Intel[®] Atom[™] Processor E6xx Series

Specification Update

July 2014

Revision 017

Figure 10. 1U Natural Convection Heatsink Mechanical Drawing

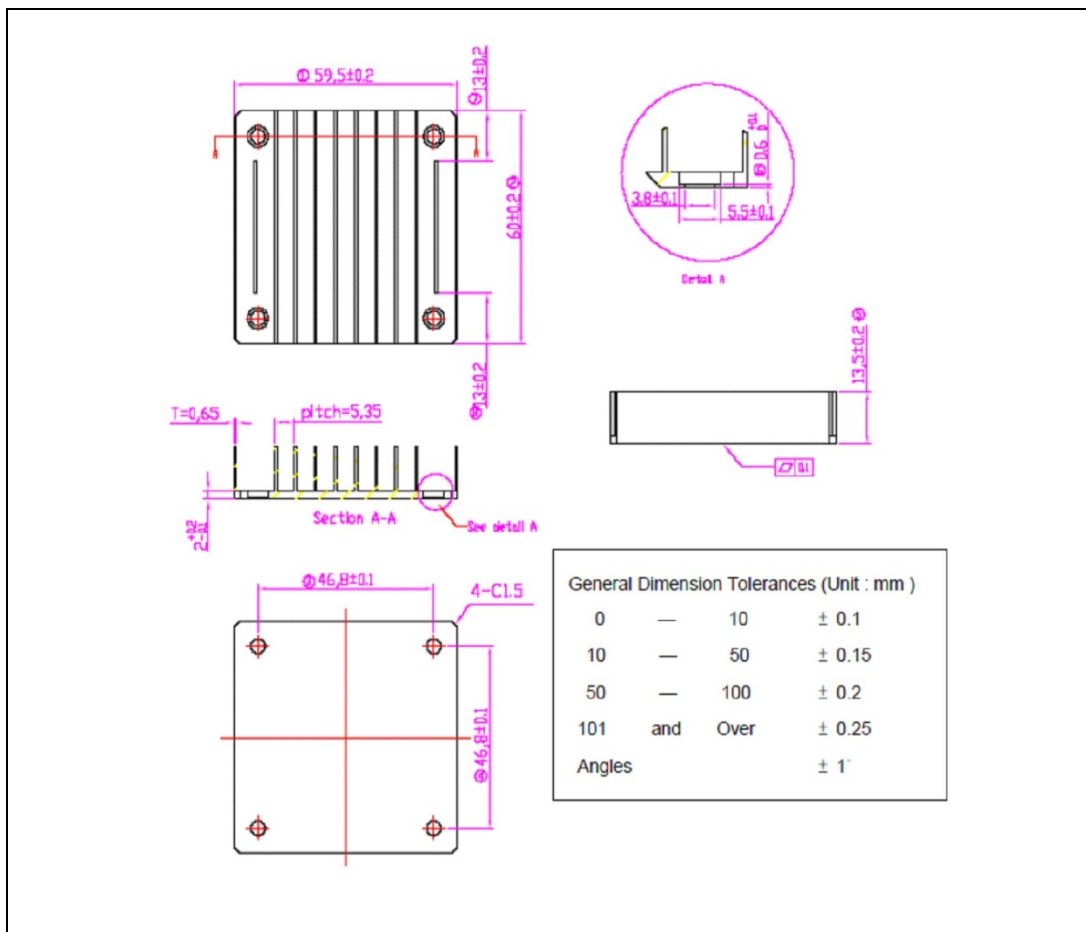
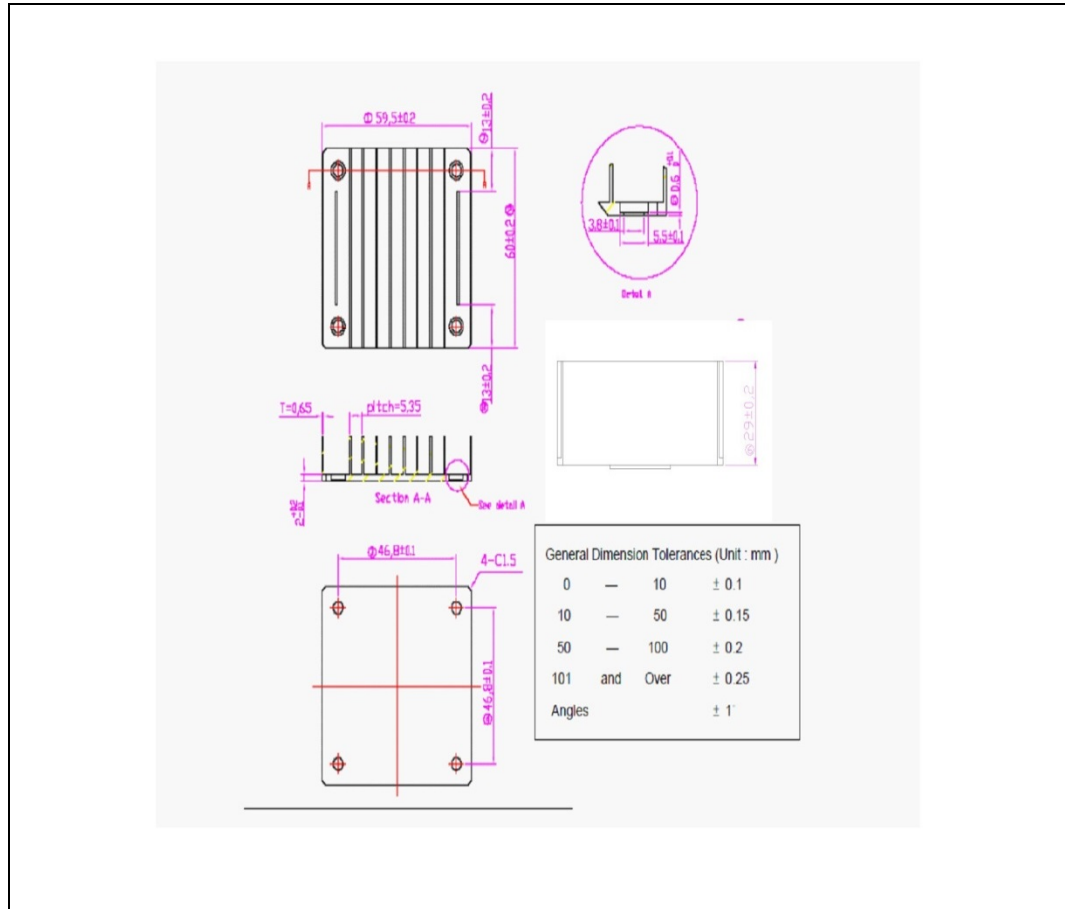
Issue: Heatsink height on Figure 10 “1U Natural Convection Heatsink Mechanical Drawing” has changed from 13.5 ± 0.2 mm to 29 ± 0.2 mm.
